# **ZONING CASE: Z2004-265**

# CASE NO: Z2004265

**SAN ANTONIO WATER SYSTEM**  
**Interdepartment Correspondence Sheet**

**Subject:** Zoning Case Z2004265 (4 acre Office\Warehouse)

# **Zoning Case Z2004265 Figure 1**

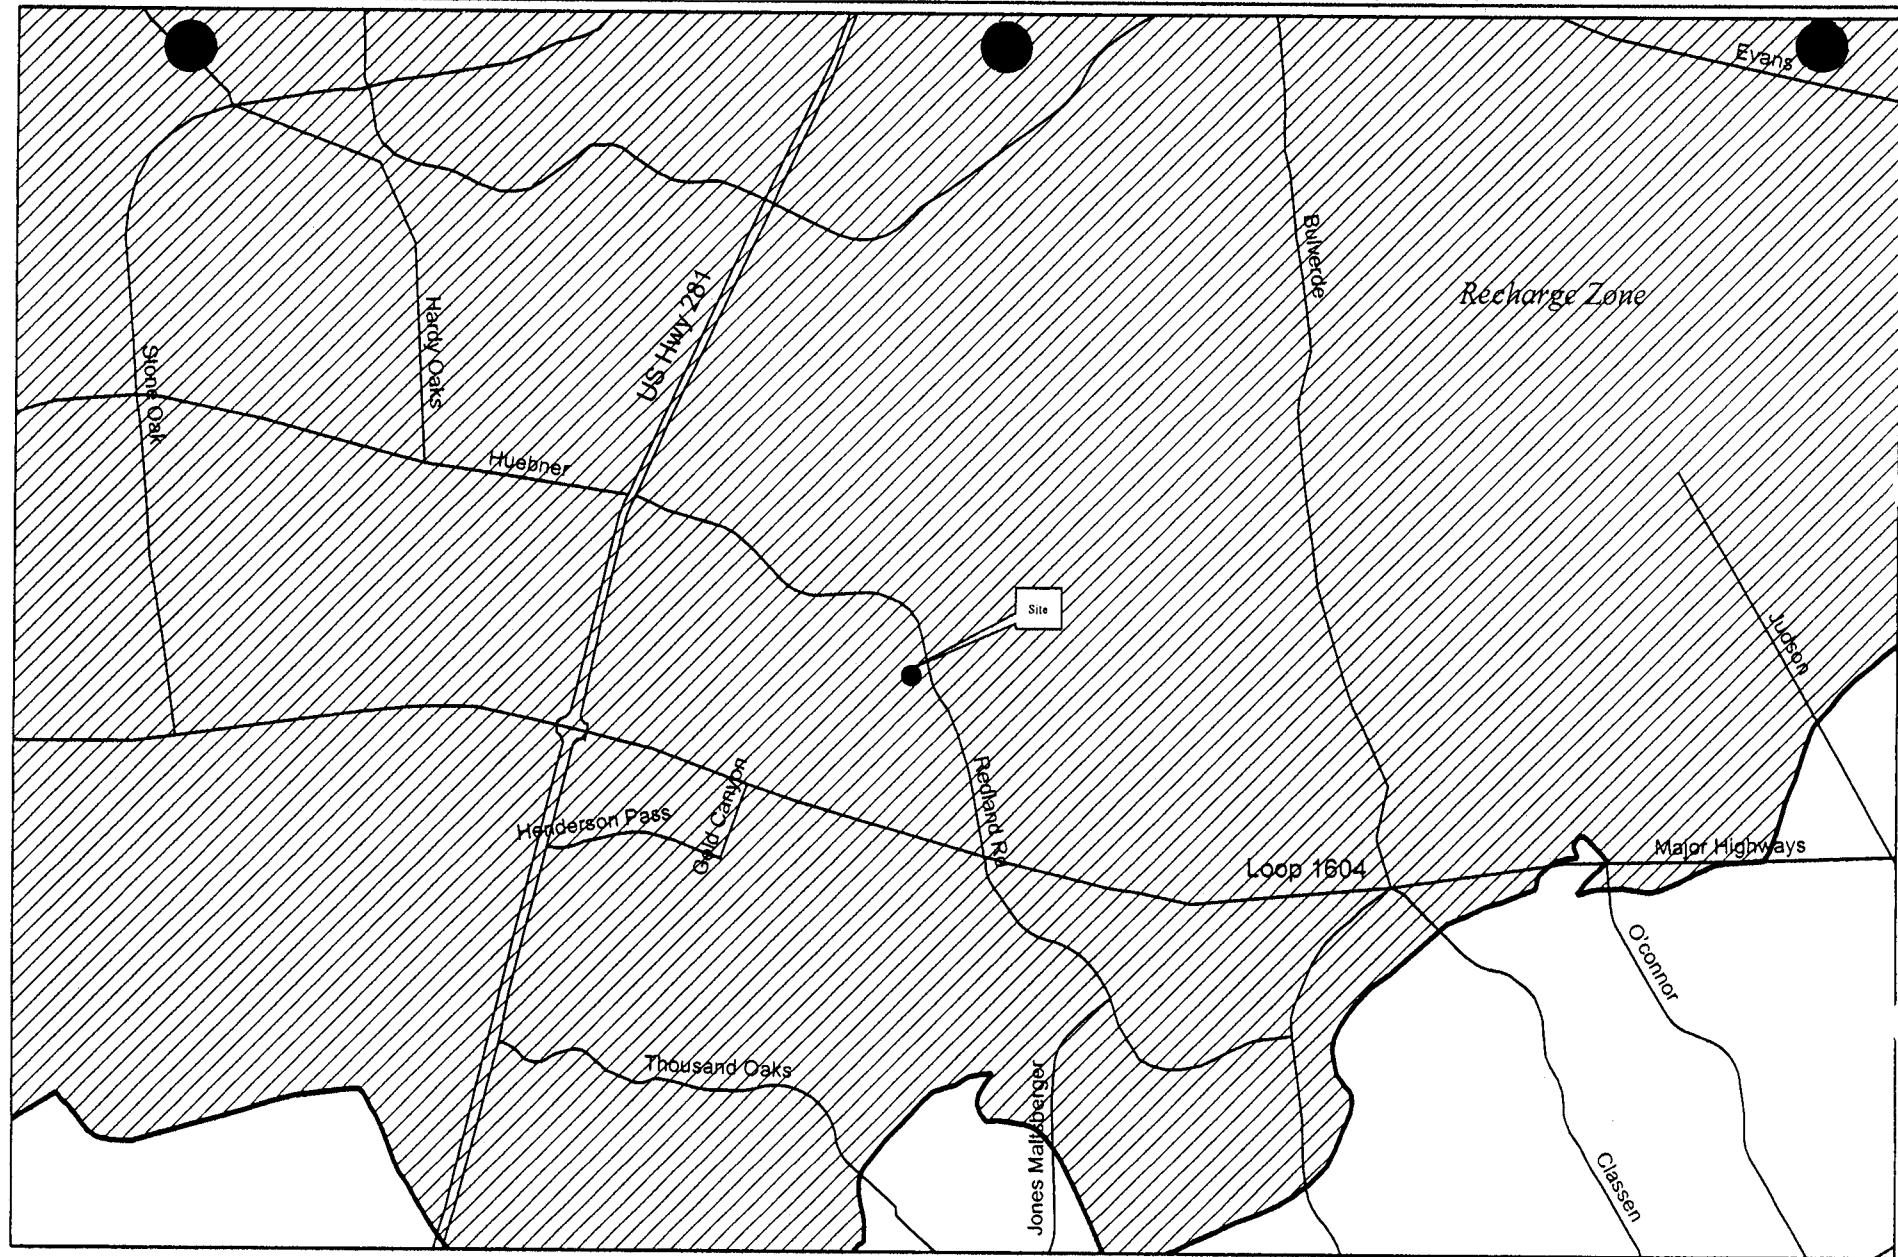
The subject property is located in City Council District 9, along the west side of Redland Road, north of Gold Canyon. The property lies within the Edwards Aquifer Recharge Zone (Figures 1 and 2).

Veni's Feature Map (Longhorn Quad)

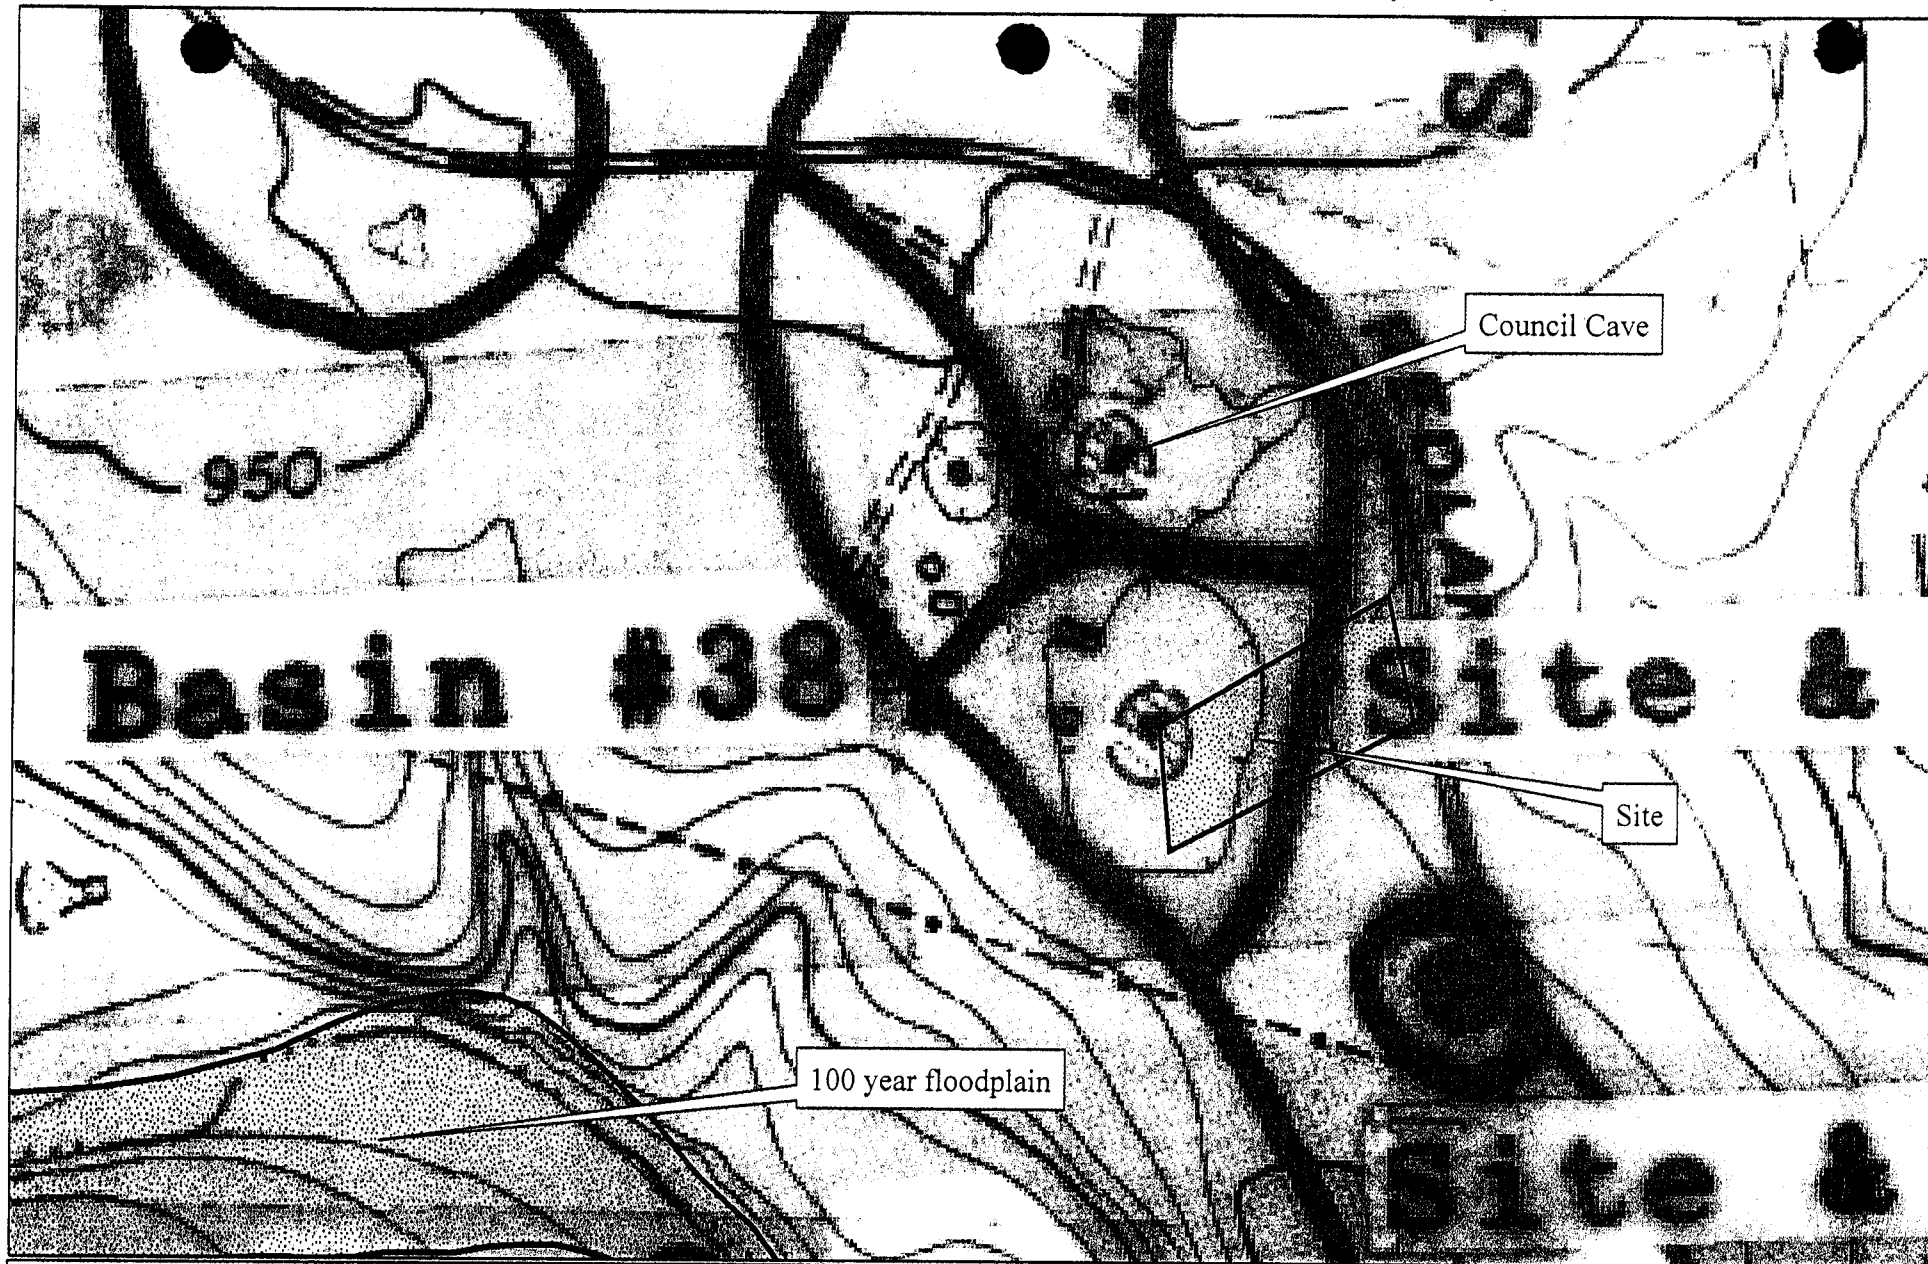
In *Significant Edwards Aquifer Karst Recharge Features of Bexar County, Texas 1989*, a report prepared by George Veni for the city of San Antonio, it states that the drainage area for the cave is approximately 22.04 acres and that the surrounding property is of low gradient. In addition, it states that included in the drainage is runoff from a nearby business via a pipe leading to the sinkhole. This report places the cave within the Longhorn Quadrangle. Additionally, the report notes three sinkholes, Redland Tri-Sinks (Basin 37, 38 and 39), in the area on and adjacent to the subject property. (Attachment 2).
